Testimony of the Sierra Club of Hawai'i to the
Senate Committee on Water and Land
March 23, 2018 2:55PM Room 224
In opposition SCR 49 and 63

RE: Testimony requesting denial of authorization for seawall and rock revetment purposes at TMK: (2) 4-3-010:009 in Kahana, Lahaina, Maui (Hololani Resort).

In response to comments provided by DPW BLNR dated 21 March, 2018, with regards to the Hololani Resort seawall providing protection to the Lower Honoapiilani Rd. and the chronic flooding:

USGS Geology

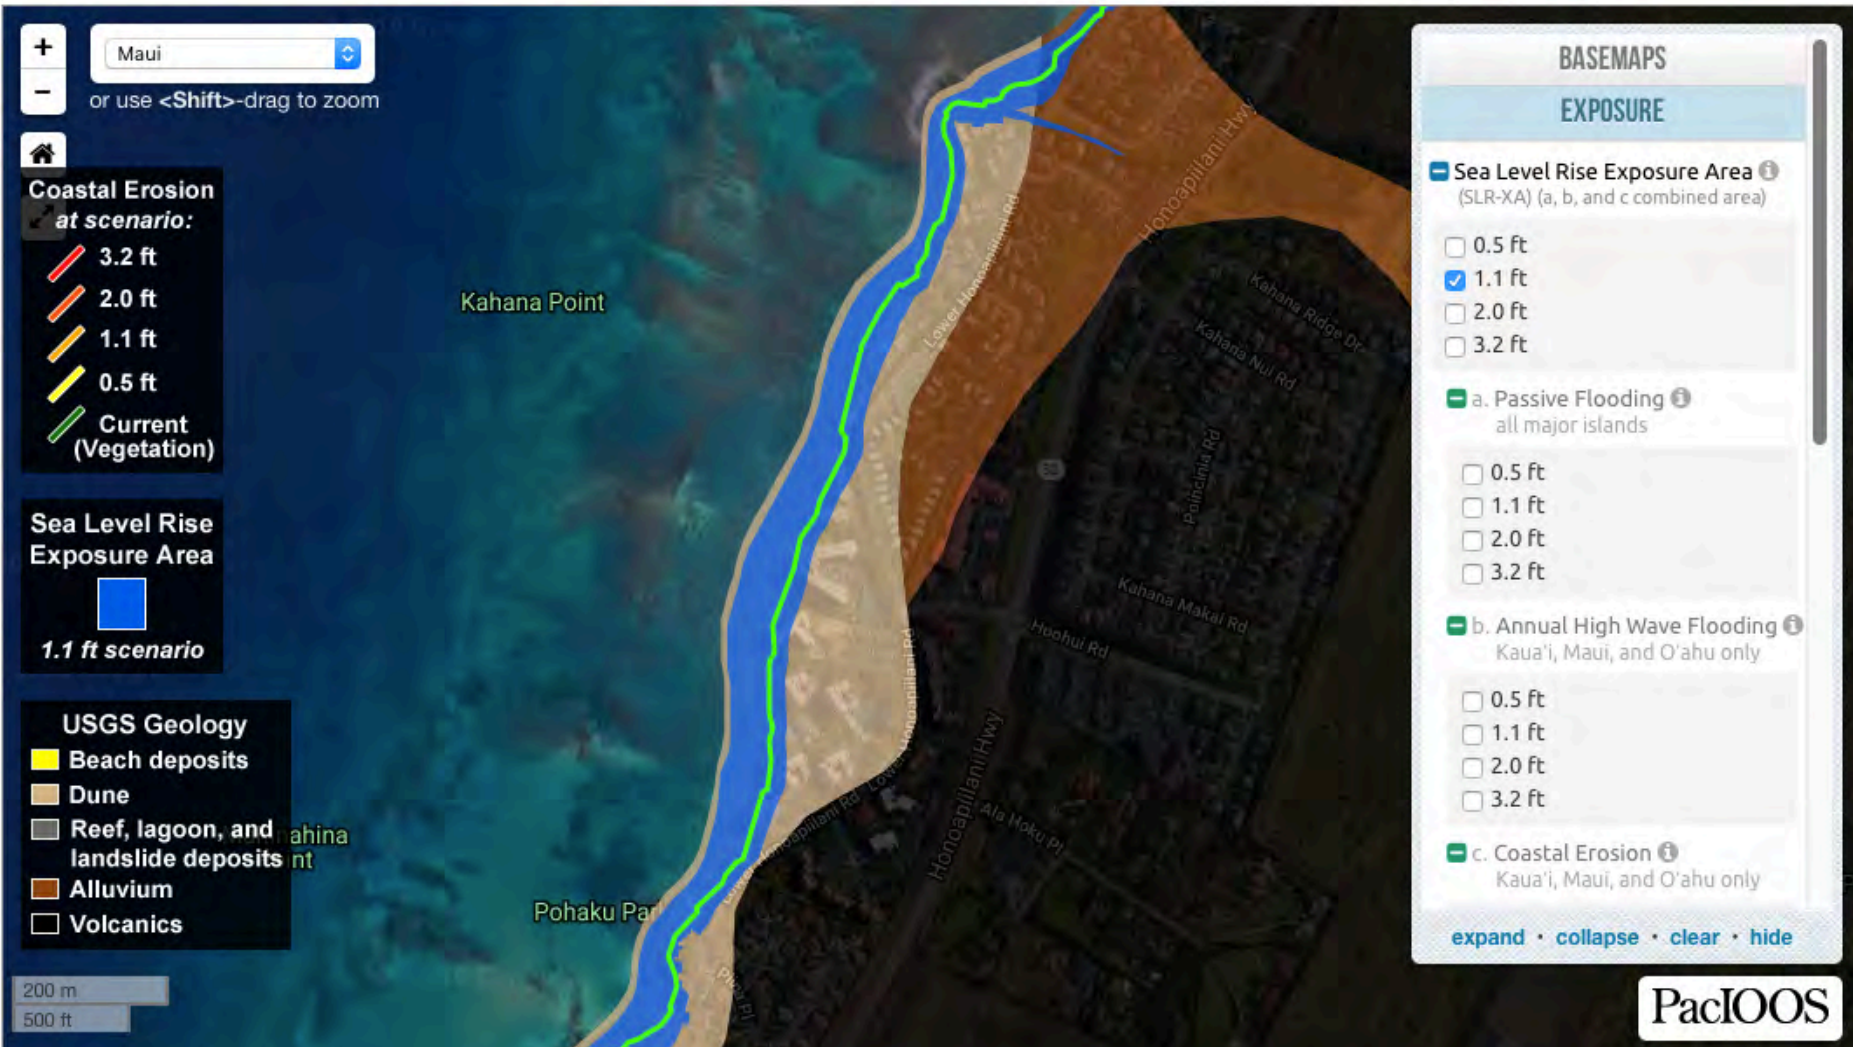
3. According to the five test borings drilled by Sea Engineering (Hololani FEA 2013, page 220) carried out to measure the underlying substrate, clay was only found on 2 of the bores and at a depth of 21 feet and 15 feet (slide 11 and 12). The area has predominantly sand and dune underlayment (slide 2 and 4). This suggests that managed retreat would sustain a beach by exposing the sand and dune substrate. Even following a 3-foot rise in sea level (by year 2100), the substrate mauka of the new high tide line will still contain sand and dune material (slide 3 and 6). And even if the underlying layer were clay, a seawall would only exacerbate the suspension of these fine sediments with increased wave energy impacting the seawall and scouring the base of the armoring, as witnessed with the Ukumehame seawall and as what continues to occur in front of the Kahana Sunset seawall.

Figure 3-2. Design cross-section for full revetment structure

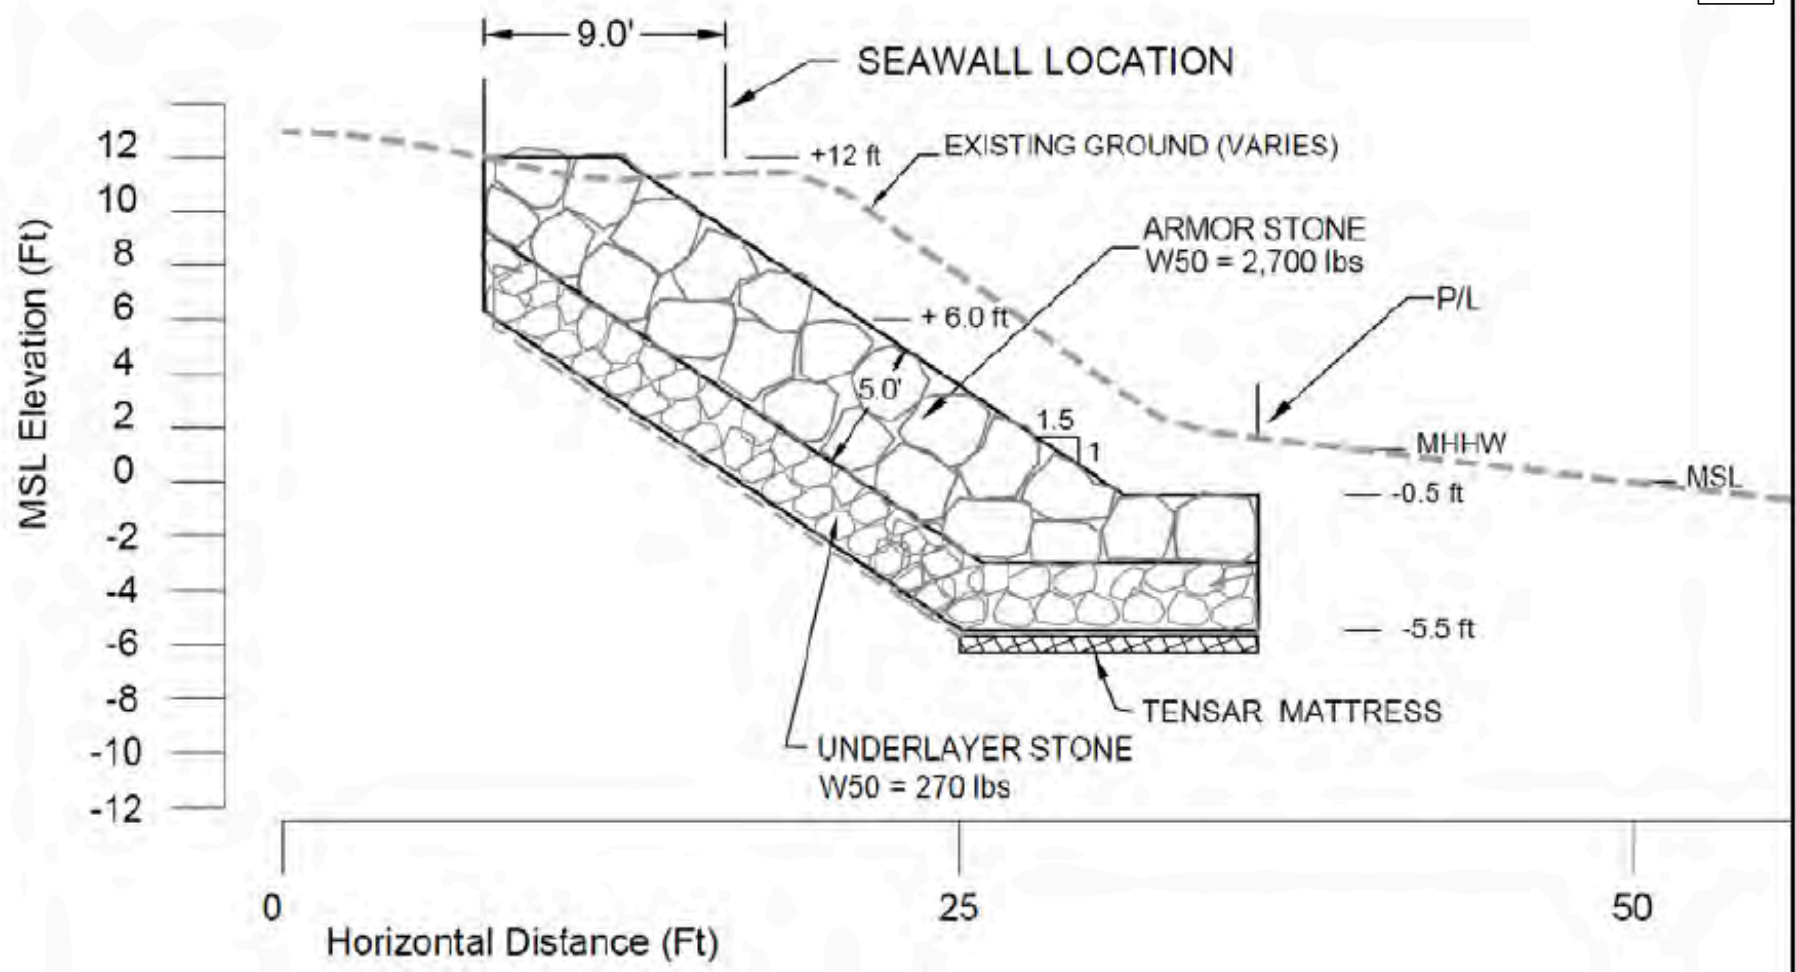
4. As far as the seawall preventing anything from entering the ocean, this is highly unlikely given that it only penetrates the ground to 6 feet below sea level at its

deepest (slide 10) and most of the underlying substrate is sand and gravel (Hololani FEA 2013). Freshwater was also detected 8 feet below the surface, which will easily carry any land-based contaminants through the porous substrate and into the ocean, especially during heavy rains.

1949

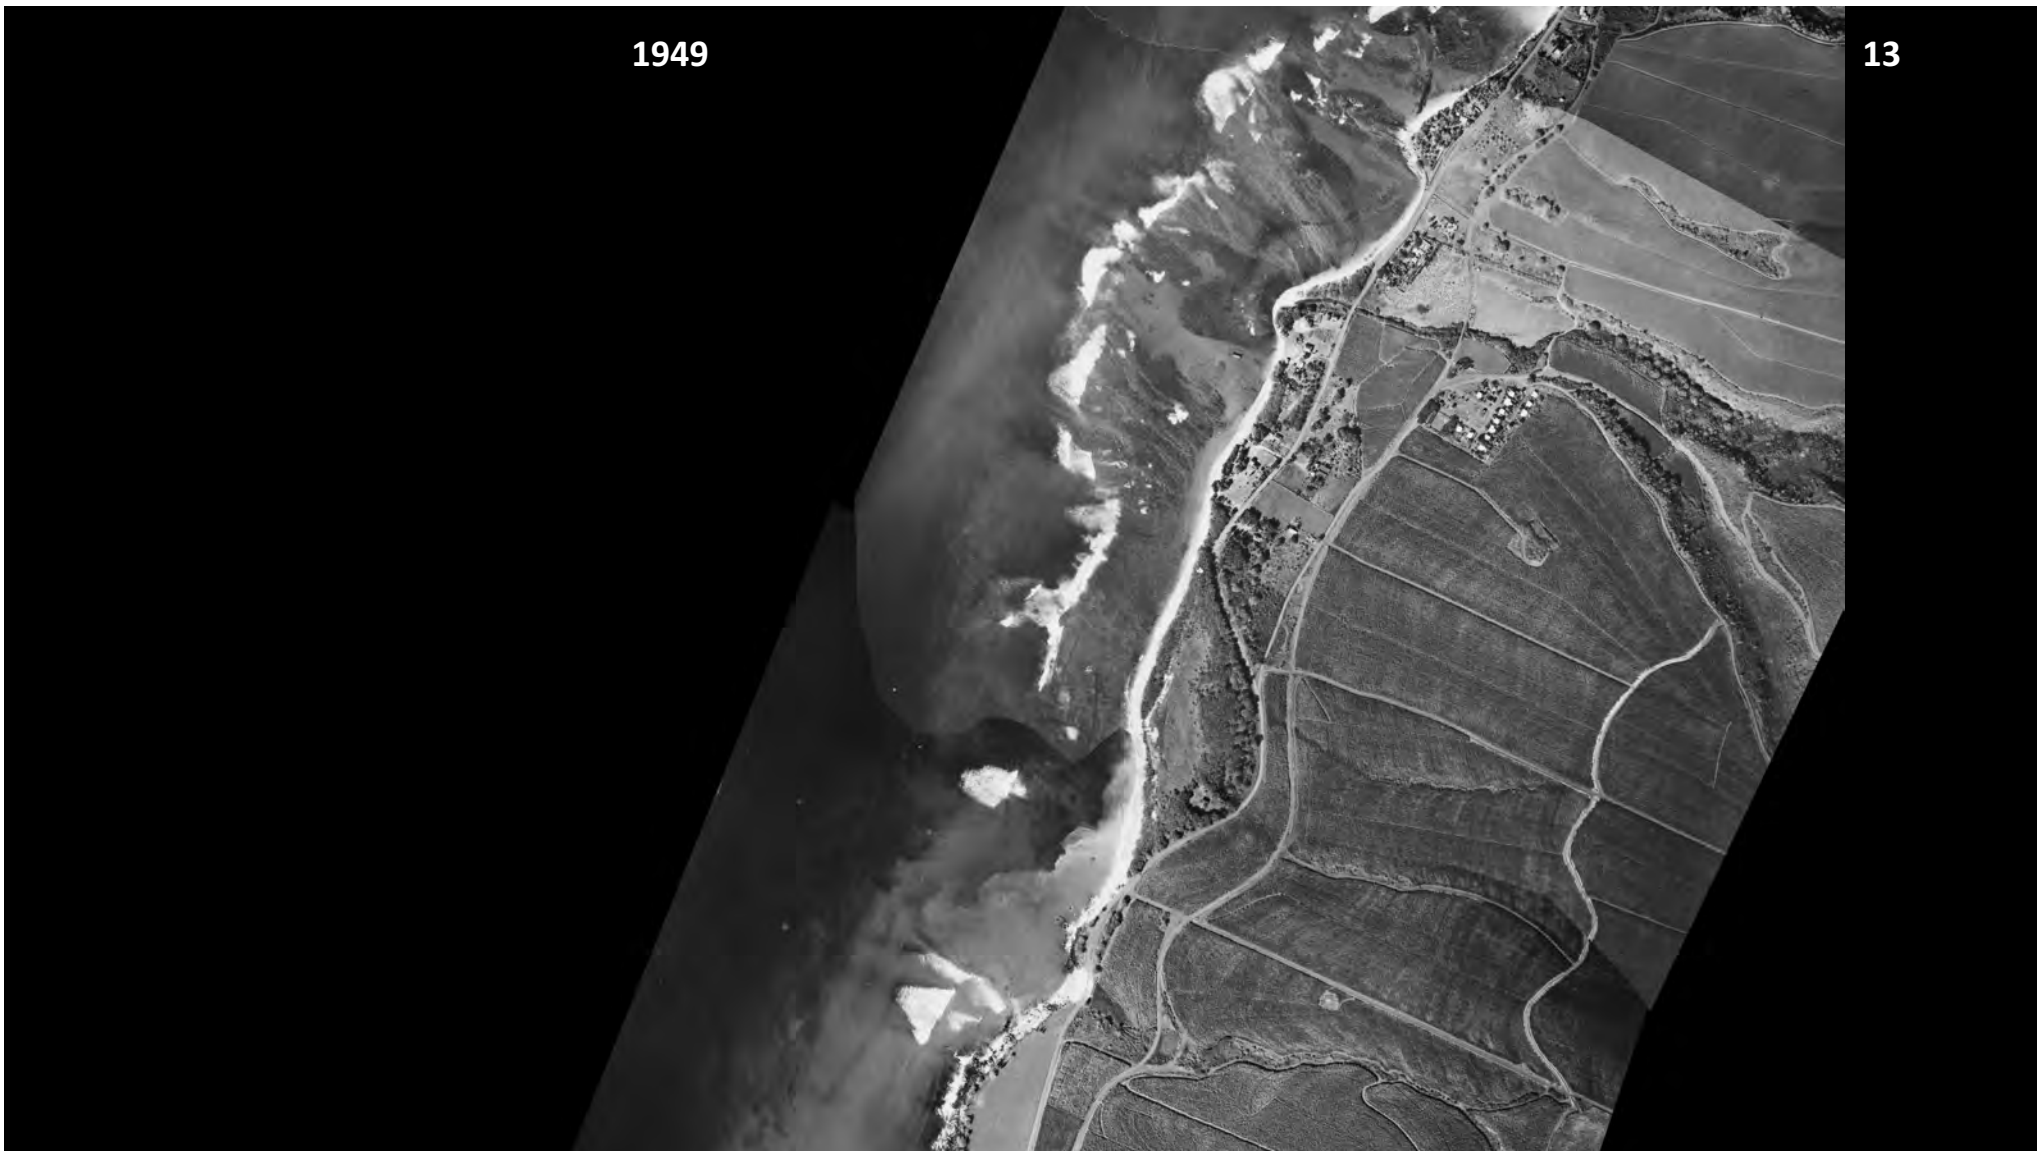
6. The stated conclusion that this particular seawall would not have a negative impact on the natural shoreline ecology seems ludicrous considering that the properties directly to the North, where shoreline armoring has been carried out, have completely lost their beach (slide 19). The aerial photo from 1949 (slide 13) clearly shows a nice sandy beach to the north but absent by the late 1980s (slide 15).
